## **Response to Camden Council by Innovation Property (UK) Ltd, June 2016**

96 Haverstock Hill (our reference: IFS-AVI-SUB-14-0052426)

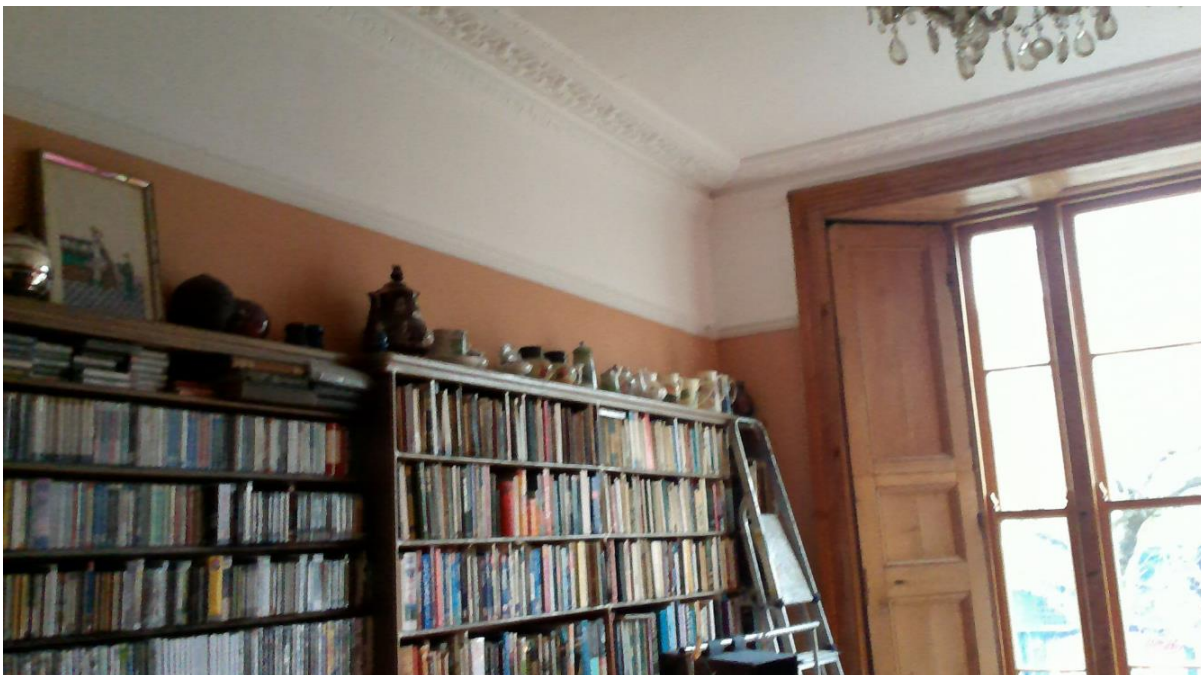
1.1. The reports that you have provided to Camden Council do not discuss any external cracking, please could we have an explanation for this, as this is quite unusual.

**We have noted a number of areas of external crack damage to both the front and rear of the property. During the recent site meeting with the local authority officers, we noted areas of new crack damage to the front elevation of the property to the right side of the front entrance steps, driveway boundary wall and exterior entranceway to the Garden Flat. We consider this is in keeping with foundation related movement i.e. subsidence.**

**This is less severe than the damage to the interior of the property, however it is evident from the monitoring that has been carried out that the majority of the front elevation has experienced relatively uniform seasonal movement, the exception being point 4 on the front right corner. Where movement is uniform, regardless of magnitude, then cracking does not occur.**

**We are also of the opinion that the previous scheme to stabilise the front entrance steps located on the right side of the building utilising a number of piles (Shire Piling) has in part resolved the subsidence movement but not prevented the internal areas of the property being affected by root induced clay shrinkage subsidence. This is supported by greater external damage being observed further away from the steps, such as to the driveway boundary wall and exterior entranceway to the Garden Flat.**

**The scheme of piling to the front entrance steps has not provided a barrier to prevent tree roots from affecting the shrinkable clay sub soil beneath the building foundations internally to the property.**
